Report on Assisted Travel at Belfast City Airport

Consumer Council for Northern Ireland

09 September 2026

Figure 1: Electric Vehicle Charging Bays

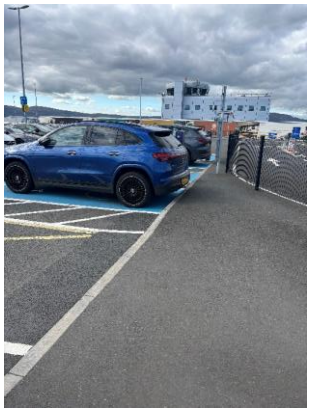
The electric vehicle charging bays in the short stay car park are marked out in blue and white (Figure 1). This is the same colour scheme used to denote blue badge parking bays which can be confusing. The group considered that green is a commonly recognised colour for electric vehicle charging bays.

- Consider providing car park pricing as displayed at the entry barrier before this point, for example online.
- Change the colour of electric vehicle parking bays to green to differentiate them from blue badge bays.

Figure 4: Assisted Travel Help Point

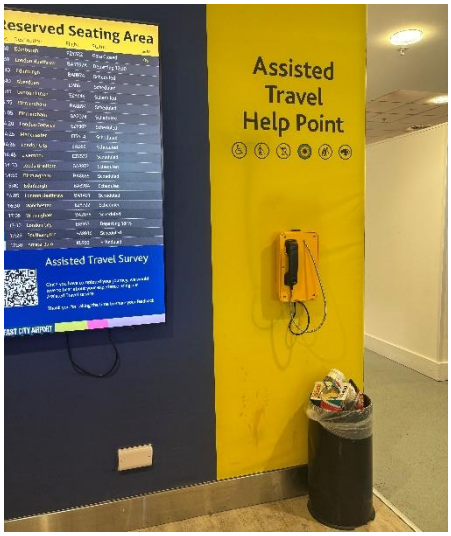
The bin below the telephone at the Assisted Travel Help Point (Figure 4) should be relocated to improve accessibility.

- Relocate bin from below the telephone at the Assisted Travel Help Point.
